500 TYPE TELEPHONE SETS

1.01 This Supplementary Addendum, which supplements Section C32.535, issue 2 and Addendum, issue C is issued to provide temporary information on several new 500 series telephone sets which are available. This Supplementary Addendum should be retained with subsequent issues of the section until notice is given covering its cancellation or reissue.

1.01 This addendum, which supplements Section C32.535, is issued to specify the use of 500-type sets in very noisy locations.

SECTION C32.535
Issue 4, May, 1954
AT&T Co Standard

Figure 3

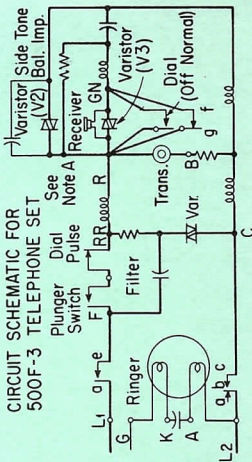
2.19 The 500E-3 (manual) and 500F-3 (dial) sets will replace 302AA and AC sets respectively. These sets are equipped with a left-hand plunger switch to minimize interference, when the hand set is removed at one of the stations on the line when the line is already in use. When the hand set is first removed a low loss a-c bridge, including the receiver and dial filter, is placed across the line. If the line is not already in use, the subscriber pulls up the plunger switch which closes the talking and dialing circuits. Since demands for 302AA (manual) telephone sets have been at levels which do not appear sufficient to warrant the manufacture of comparable 500E-3 (manual) sets,

A. 500E-3 (For Manual Service) same as 500F-3 except replace dial with apparatus blank and strap terminal on plunger switch to (RR) terminal on network with black lead as shown.

B. When the handset is removed, contact, *gf*, breaks last.

Figure 4

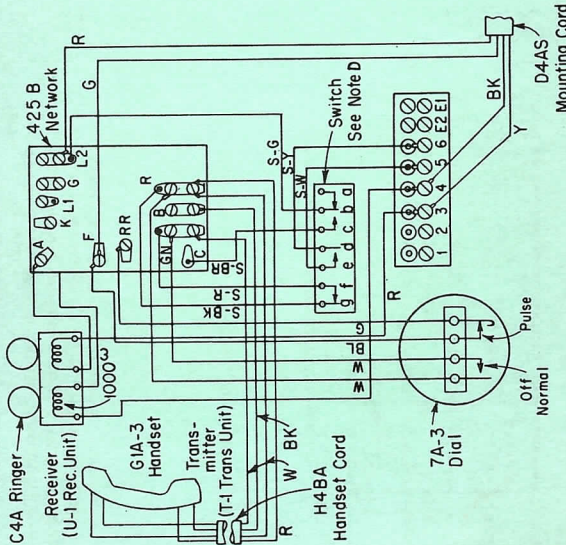
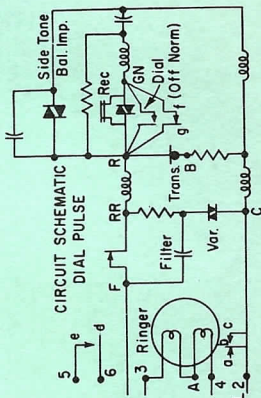
2.20 The 500L-3 (manual) and 500M-3 (dial) telephone sets do not replace any apparatus. These sets are similar to the 500C-3 and 500D-3 telephone sets except for an added terminal strip and a different switchhook circuit arrangement. These changes provide for separate talking and ringing circuits for use with 1A Telephone Answering Sets, 2B Key Telephone Systems and 507A and 507B P.B.X. attendant stations. They also permit the use of additional ringing bridges in specific instances when needed where a local ringing source is available. The 500L-3 (manual) set will be obtainable only by conversion.

A. For manual service: (500 L-3) same as 500 M-3 except replace dial with apparatus blank and transfer green lead from (F) to (RR) terminal on network.

B. When ringer condenser is required in series with ringer, transfer slate ringer lead to (K) terminal on network.

C. Contact sequence:

Removing handset- 1. de closes before cb
2. fg opens

Restoring handset- 1. fg closes
2. cb opens before de
